Sample Approval Form

Die #: 15299
Description: D.H.D.S Common Sash

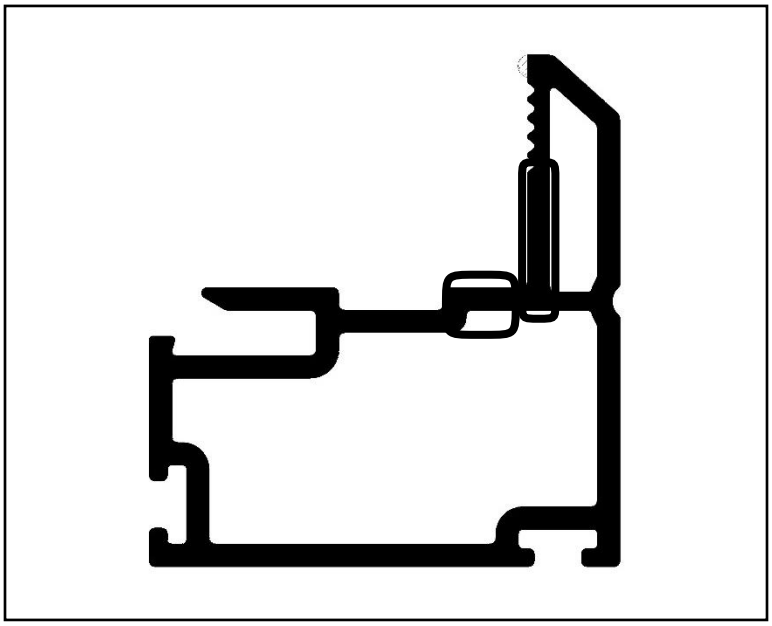
Comments: The tower wall with silicone ridges is slightly thin mic = .055 spec .062
The wall perpendicular to the tower wall is also slightly thin mic = .055 also.
All other dimensions and walls are good
